Subject: AP1000 COL Standard Technical Report Submittal of APP-GW-GLN-012-NP, Revision 2
(WCAP-16716-NP, Revision 2)

APP-GW-GLN-012-NP, Revision 2
(WCAP-16716-NP, Revision 2)

“AP1000 Reactor Internals Design Changes”

Technical Report 29

Figure 3-1 Elevation View of Reactor Bottom Vessel Head, Flow Skirt, and Lower Core Support Plate

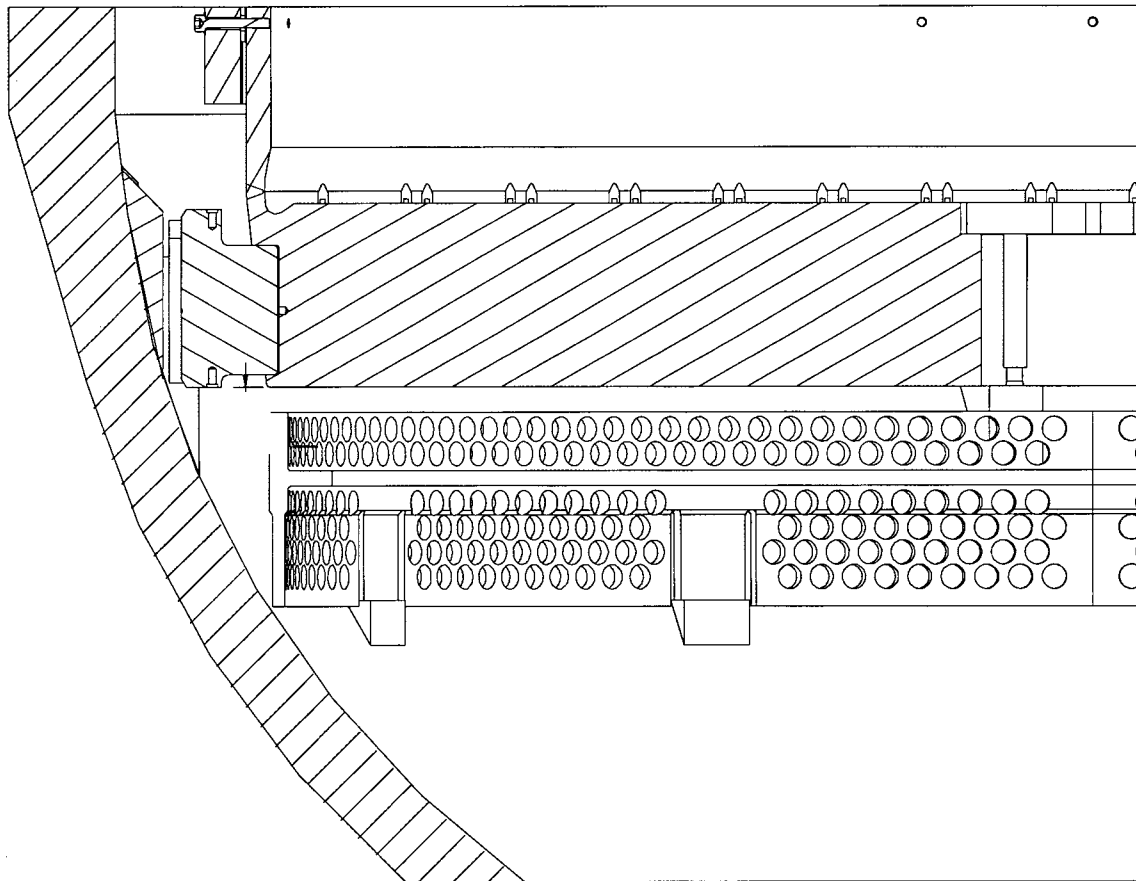
The results of the CFD calculations using the existing structures in the lower plenum along with the LCSP flow hole geometry indicated that the core inlet flow distribution needed to be adjusted to create a more uniform core inlet flow distribution. The core inlet flow distribution was improved by the addition of a flow skirt to the lower plenum of the reactor vessel.

CFD analyses of numerous configurations of the hardware in the lower reactor vessel have been made with the objective of obtaining a core inlet flow distribution that meets specifications established by the Westinghouse fuel group. It has been determined that flow distributions that meet the requirements are obtained with a flow skirt. A flow skirt is a perforated cylinder in the lower reactor vessel head that is attached to the reactor vessel bottom head (See Figures 3-1 and 4-1). The flow skirt is attached to the lower head of the reactor vessel at the plant site after measurements for machining of the core barrel clevises have been completed. The attachment consists of welds across eight tabs that rest on support lugs provided on the reactor vessel lower head.

There is a circumferential weld between the spherical bottom vessel head and the conical transition to the cylindrical portion of the reactor vessel. The weld is just above the top surface of the flow skirt support lugs. There is some radial clearance between the outside of the flow skirt and the inside surface of the reactor vessel at the circumferential weld location. Examination Category B-N-2 of Section XI, Subsection IWB-2500, provides requirements for the visual (VT-3) examination of "interior attachments beyond the beltline region" of the reactor vessel. Vertical access for a pole-mounted camera is possible around the full circumference of the flow skirt with partial blockage at the four lower radial support keys located on the cardinal axes. It has been judged that the flow skirt and attachment welds could be inspected using VT-3 examinations. If any relevant condition is detected, IWB-3122 (prior to service) or IWB-3142 (in-service) provides options for correcting the condition.

Figure 4-1 Changes to Reactor Internals Interface Arrangement (DCD, Figure 3.9-8)

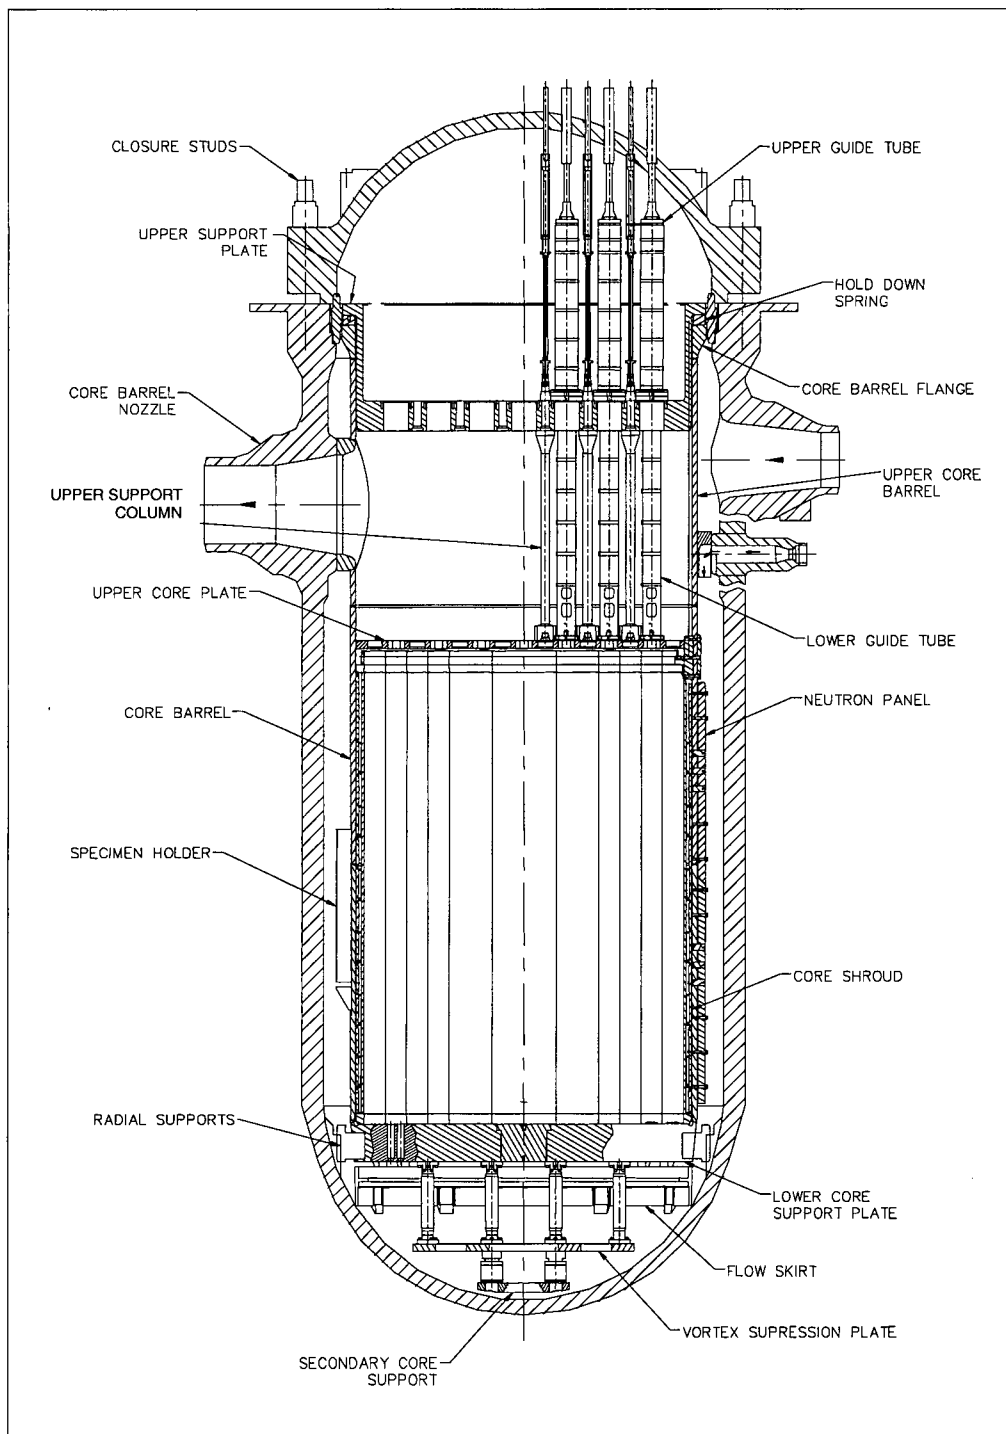
Figure 3.9-8, page 3.9-177 of DCD Revision 15: This figure is modified to show:

- Tapered outer diameter of the lower core support plate
- Neutron panels
- Flow skirt

Figure 4-2 Changes to Reactor Internals Interface Arrangement (DCD, Figure 3.9-5)

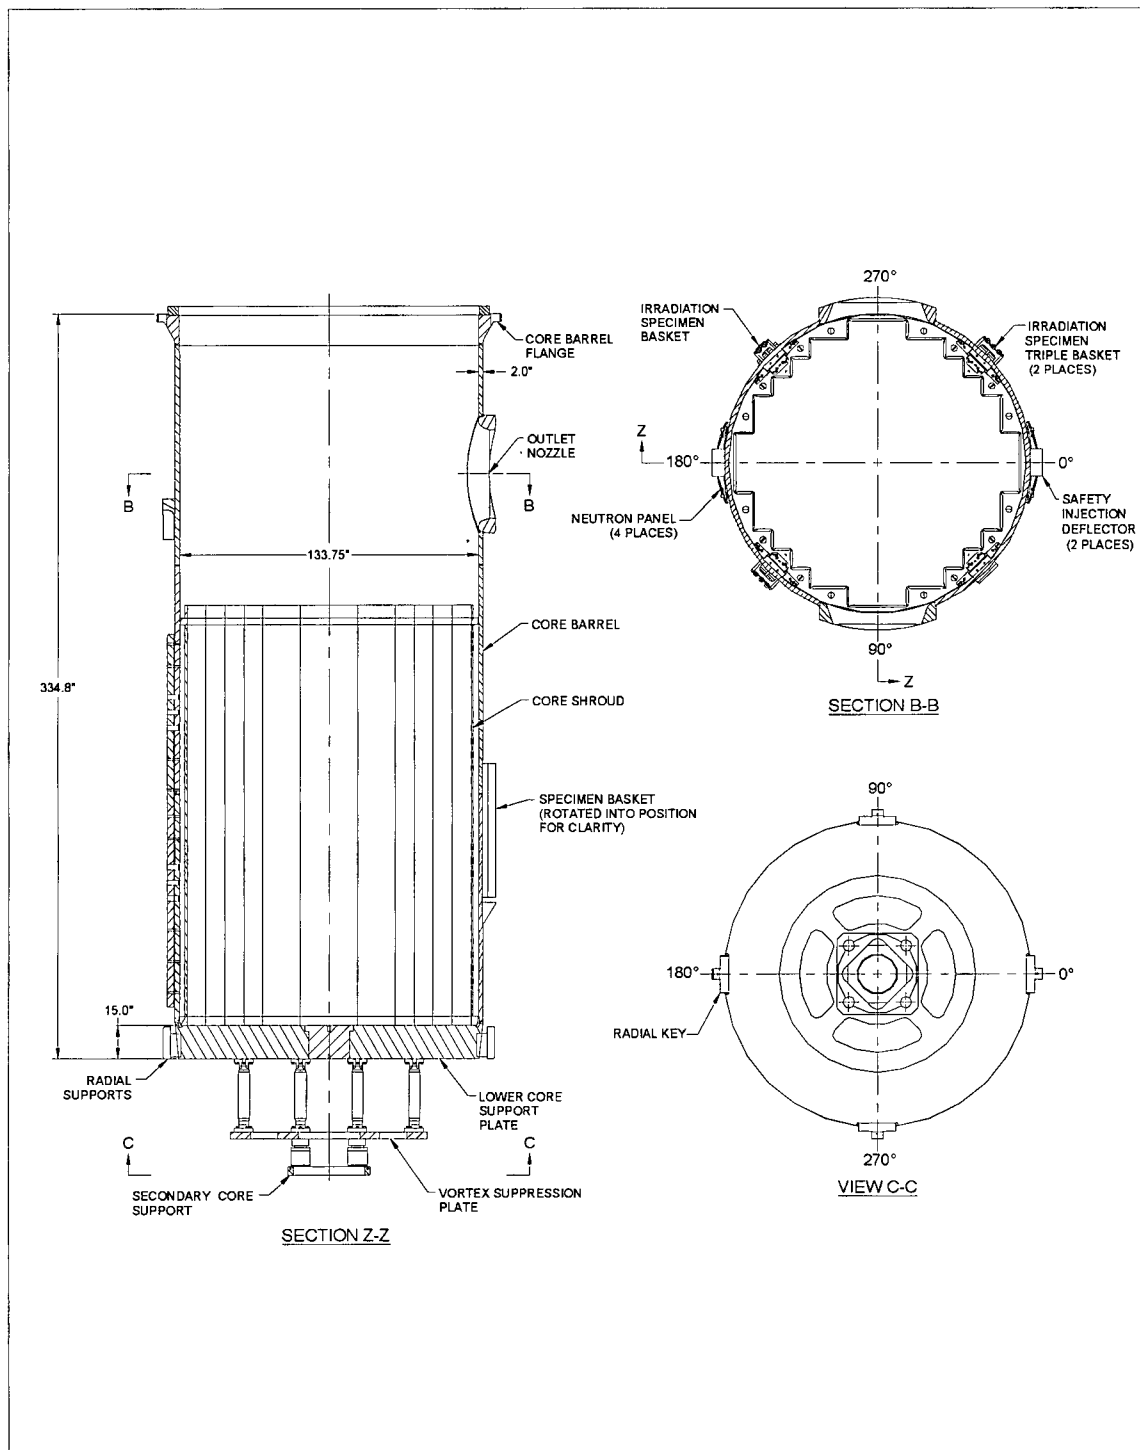
The neutron panels are located at four circumferential locations where fuel assemblies are closest to the reactor vessel (0, 90, 180, and 270 degrees) as shown in Figure 4-2. Each pad covers ~30 degrees circumferentially and extends over the entire length of the active core region (14 feet). The pads are contoured to minimize the impact on the downcomer annulus flow area and to reduce the probability of vortex generation in the downcomer.

Figure 3.9-5, page 3.9-174 of DCD Revision 15: This figure is modified to show:

- A “rotated into position for clarity” statement is added for specimen basket.
- Neutron panels
- Radial keys on cardinal axes, not at 45 degrees
